**ANSI/AHRI Standard 550/590 (I-P)
with Addendum 3**

**2011 Standard for
Performance Rating Of
Water-Chilling and
Heat Pump Water-Heating
Packages Using the Vapor
Compression Cycle**

AHRI STANDARD 550/590 (I-P)-2011 WITH ADDENDUM 3

Performance Rating of Water-Chilling and Heat Pump Water-Heating Packages Using the Vapor Compression Cycle September 2013

Figure C1. Sample of Relative Calibration Evaluation Data (Percent of Reading)

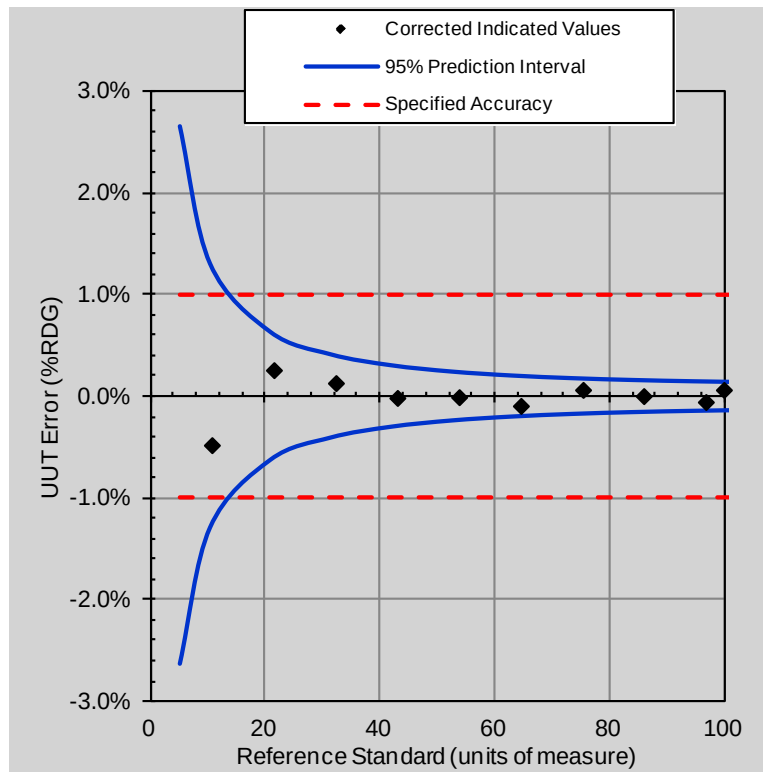
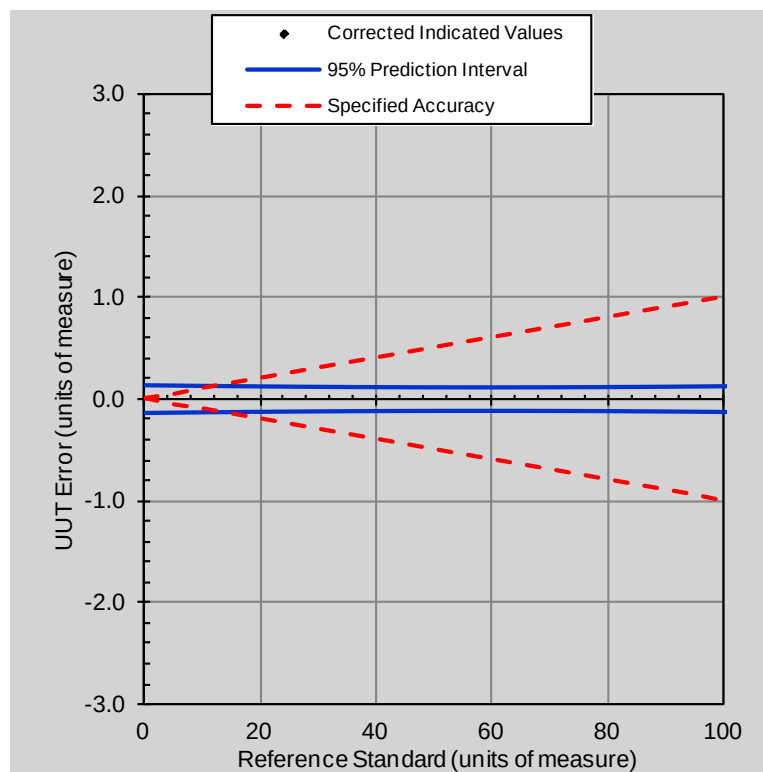
5. Remove Table C2, Figures C1 and C2 and replace with revised Table C2, Figures C1 and C2.

Figure G1. Examples of Piezometer Ring/Manifold

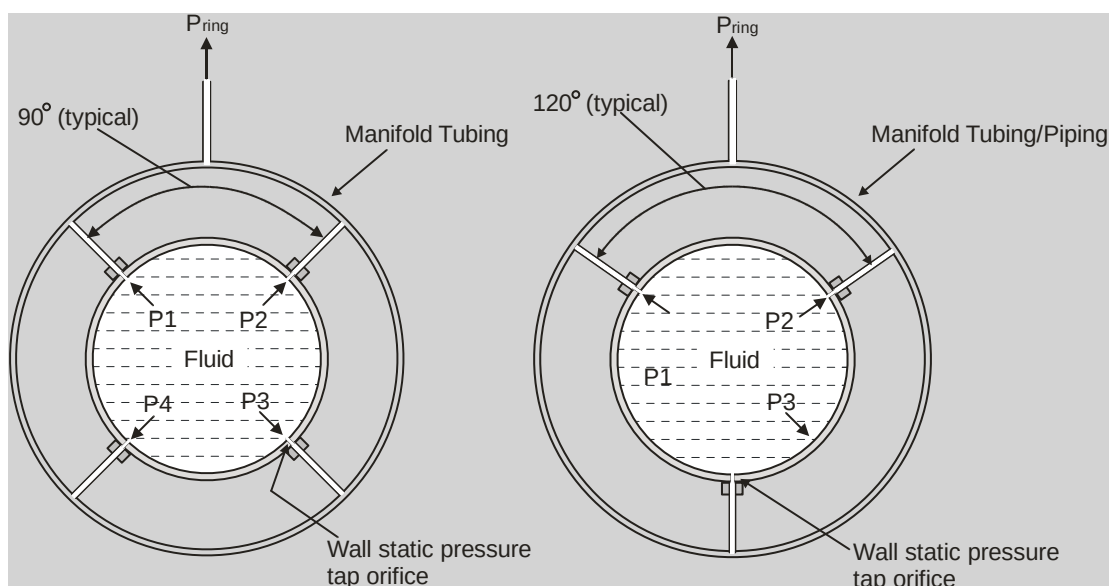
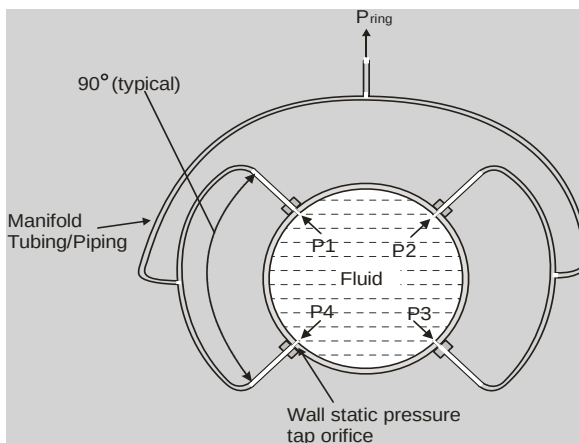
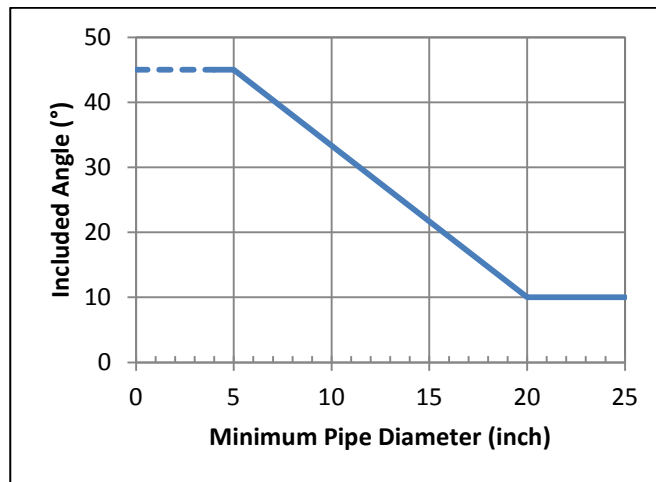
7. Remove Sections G1, G2 and G3, and replace with revised Sections G1, G2, and G3, including new Sections G4 and G5, and new Figures G1 and G2.

G4 *Static Pressure Taps.* Static pressure taps will be in a piezometer ring or piezometer manifold arrangement with a minimum of 3 taps located circumferentially around the pipe, all taps at equal angle spacing. To avoid introducing measurement errors from recirculating flow within the piezometer ring, each of the pipe tap holes shall have a flow resistance that is greater than or equal to 5 times the flow resistance of the piezometer ring piping connections between any pair of pressure taps. A “Triple-Tee” manifold arrangement using 4 pipe tap holes is the preferred arrangement, but not required if meeting the flow resistance requirement.

G5 *Correction Method.* Measured water pressure drop values shall be adjusted to subtract additional static pressure drop due to external piping. The additional static pressure drop shall be the sum of all losses between the unit connections and the location of static pressure taps. Record the original measured value, the calculated adjustment value, and the final calculated

Figure C1. Sample of Calibration Evaluation Data (Percent of Reading)

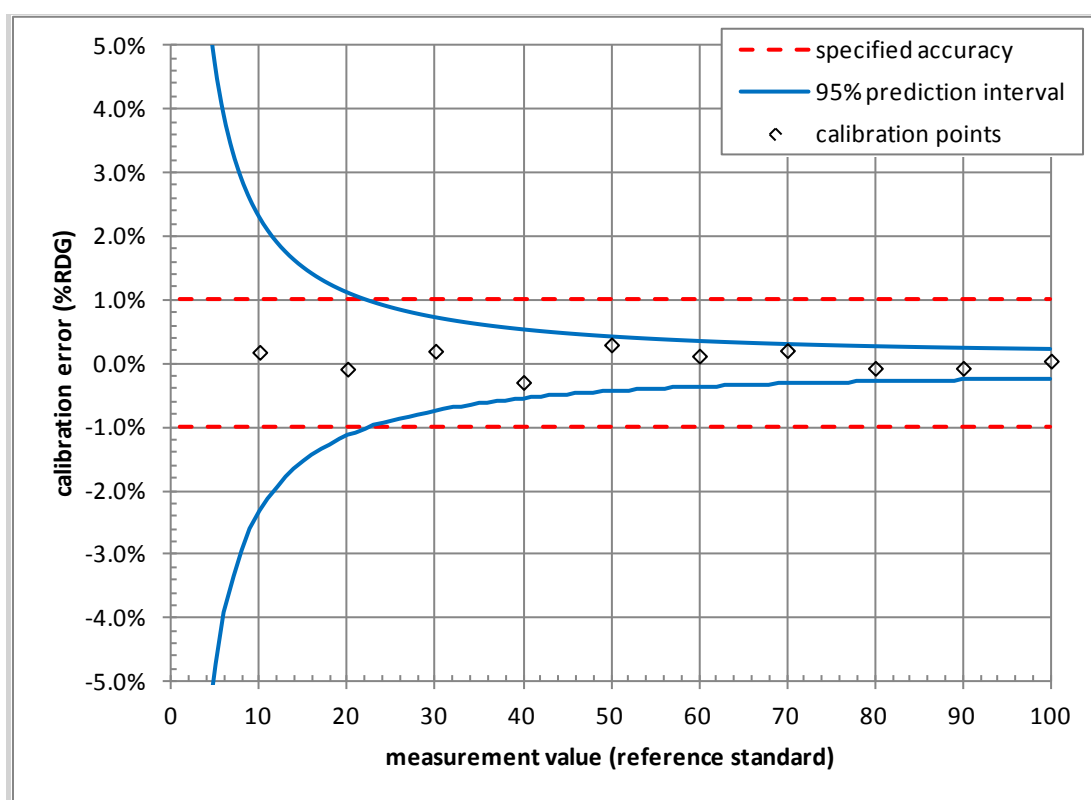
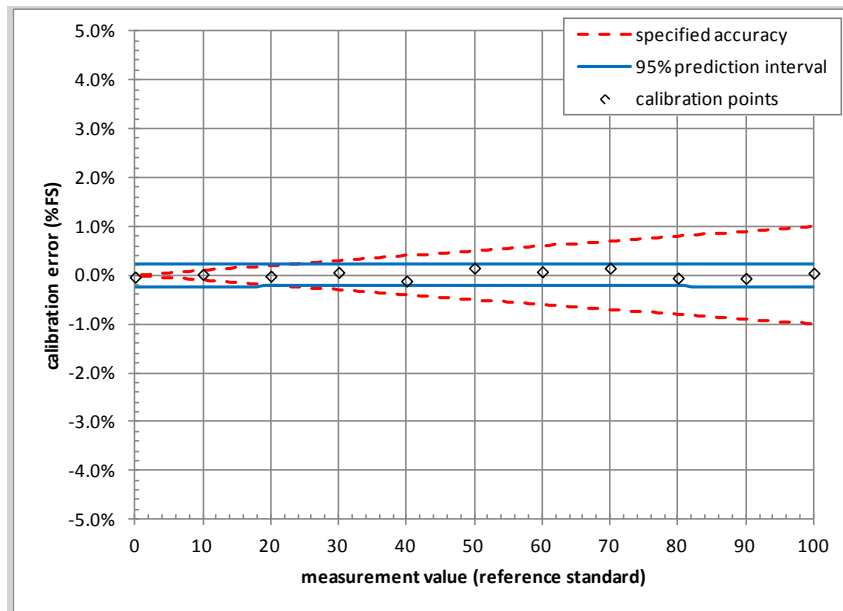
5. Remove Section C4 and replace with revised Section C4, including revised Table C1, added new Table C2

and new Figures C1 and C2.
